From: <Richard.Olsson@ski.se>
To: OWFN_DO.owf4_po(RFD)
Date: Thu, Apr 27, 2000 5:21 AM
Subject: VB: Draft Final Technical Study SFP Risks at Decom NPPs

ES-konsult
ENERGI OCH SÄKERHET AB**Memorandum**

Questions/Comments on the NRC "Draft final technical study of spent fuel accidents risk at decommissioning nuclear power plants", 7590-01-P.

FIGURE 1: Envelope Ground Response Spectra for a (principal) horizontal GM direction, relating to exceedance frequencies 10^{-5} , 10^{-6} and 10^{-7} annual events per site and damping ratios 0.005, 0.02, 0.05, 0.07 and 0.10.

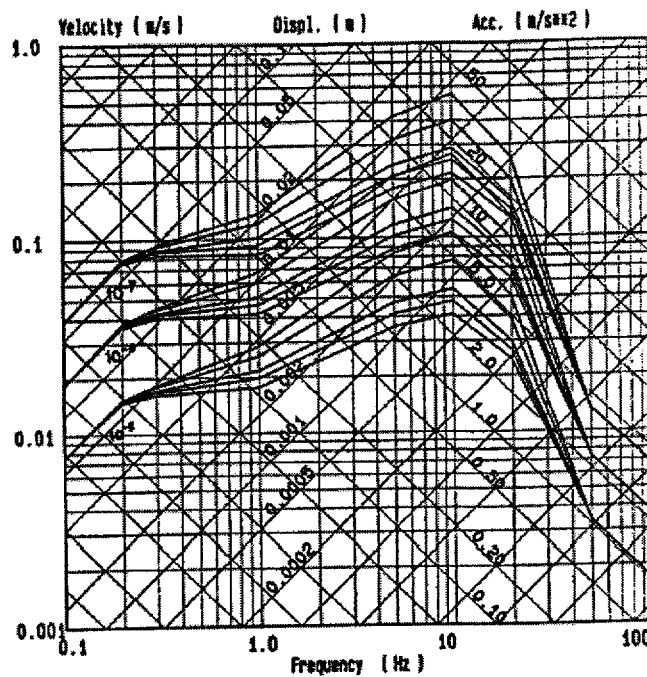
Limits on fire propagation will directly limit the possible radioactivity releases and fatalities e.t.c.
5. An US earthquake response spectra 10^{-5} /year (0.5g) is considered as a 10^{-7} in Sweden. Does this justify exemption from further consideration, due to low yearly frequency for Zr-fire? The SFP at the Swedish plant is calculated with an earthquake 0.1g, see response spectra Figure 1, and found to comply with the Swedish standard design standard (Boverkets Konstruktionsregler 94, BKR94.
